Amended Section 75W to Concept Plan (MP10_0003)

Discovery Point, Wolli Creek

Submitted to Department of Planning and Infrastructure
On Behalf of Discovery Point Pty Ltd and Discovery Point Devt Pty Ltd

November 2012 ■ 12505

Figure 2 – Comparison of existing and proposed basement extent (northern and southern precinct)

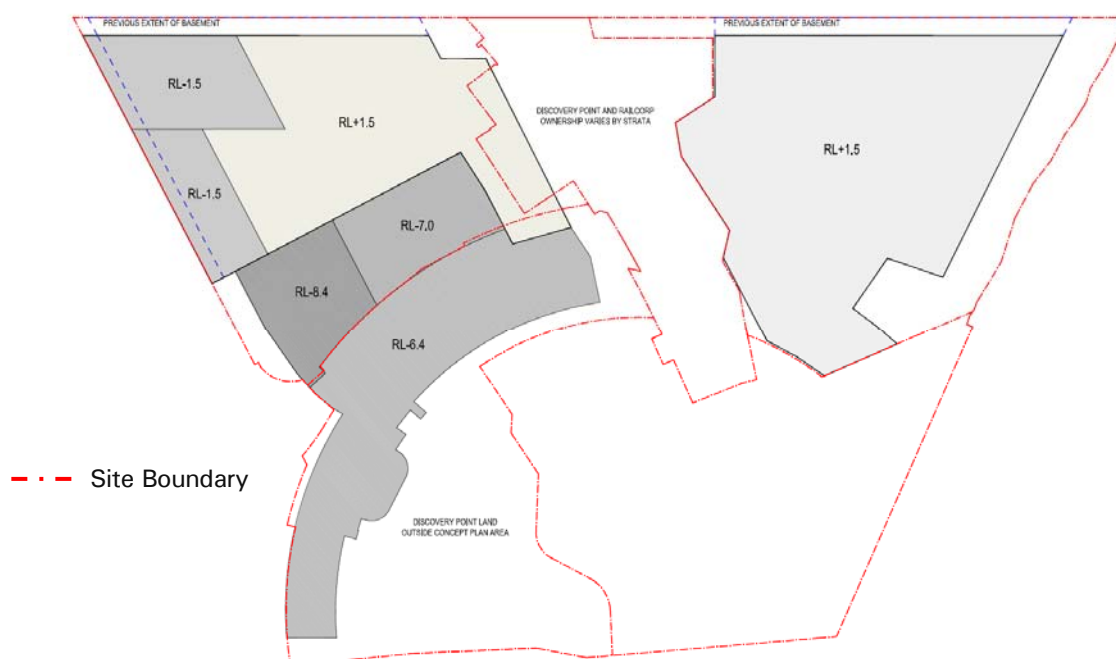
The approved basement extent diagram (DA3-B01) included basement parking in close proximity to the Illawarra and South Coast Rail Line. Detailed design development of individual stages has however resulted in a review of the relationship of the basement extent to this adjoining rail corridor.

Accordingly, it has been determined that a more appropriate outcome from both a buildability perspective (in terms of enabling simpler construction of basement structures) and interface perspective (in terms of minimising/avoiding potential impacts on the rail corridor) would be achieved through pulling the basement away from the rail corridor. This proposed change has been discussed with RailCorp as part of the on-going rail interface discussions.

Correspondingly, it is proposed for the basement extent to be pushed south towards Magdalene Terrace within the boundary of land still owned by Discovery Point Pty Ltd.

The result of the proposed reconfiguration to the basement extent is a smaller footprint across the site. This is beneficial in limiting the potential impact on the railway line.

Figure 2 below illustrates the proposed shift/reconfiguration in the basement extent and confirms that the revised basement extent does not encroach into Council owned land along Magdalene Terrace.

Figure 3 – Preliminary sketch of Level 1, Building 4

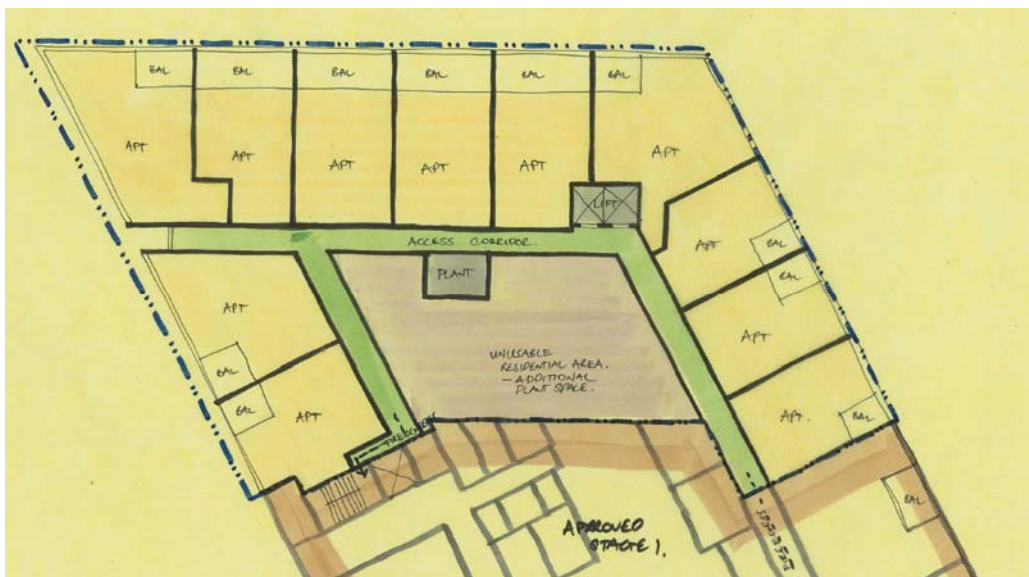
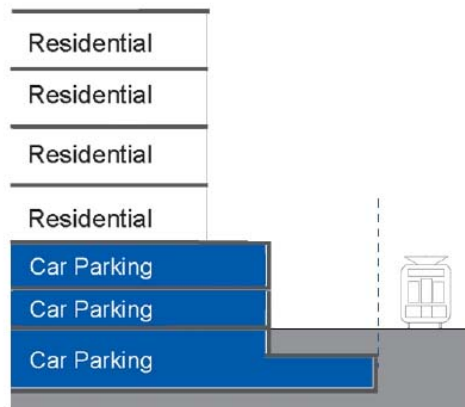
This Modification Application seeks to re-introduce above ground parking at the first floor level (podium) of future Stage 4. The Modification Application to the Stage 1 Project Approval lodged concurrently with this application includes details regarding future access to this level of above ground parking by amending the approved ground floor layout with a ramp to Level 1 (with the future Stage 4 DA to include specific details regarding car park layout and appropriate façade treatment).

The additional level of parking on the first level/podium of Stage 4 will also require an amendment to the maximum amount of above ground parking approved under the Concept Plan from 8,000m² to 9,200m². This increase in above ground parking extent will equate to approximately 28 car parking spaces.

There are a range of other factors that further support the use of the first floor/podium of Stage 4 for car parking and reinforce that the modification is more than just a response to parking, including:

- Special design treatment considerations required in order to comply with RailCorp requirements for balconies within 20m of a rail corridor. This includes enclosed or screened balconies with limited opportunities for openings and would result in poor amenity for future residents at this first floor level.
- The core location and relationship with existing approved apartments within Building 1B at first floor level results in an inefficient and generally poor apartment layout. This is illustrated within the preliminary sketch prepared by PTW Architects at **Figure 3**, which highlights:
 - A number of single aspect apartments with a depth greater than the RFDC requirement of 8m.

- Floor plate planning results in a large unusable area of 215m².
- Only 2 of the 11 apartments would have dual aspect, the remaining apartments will have single aspect.
- Only 2 of the 11 apartments would achieve natural ventilation.
- Floor plate planning results in a very long single loaded corridor, which will need the introduction of fire doors within the corridor to reduce fire escape travel distances
- The interface issues between potential first floor apartments being located directly above a loading dock (with all its associated potential noise, vibration and odour issues).
- Privacy issues associated with having residential apartments at the direct eye height of pedestrians located on the adjoining railway platform together with noise issues from platform announcements.
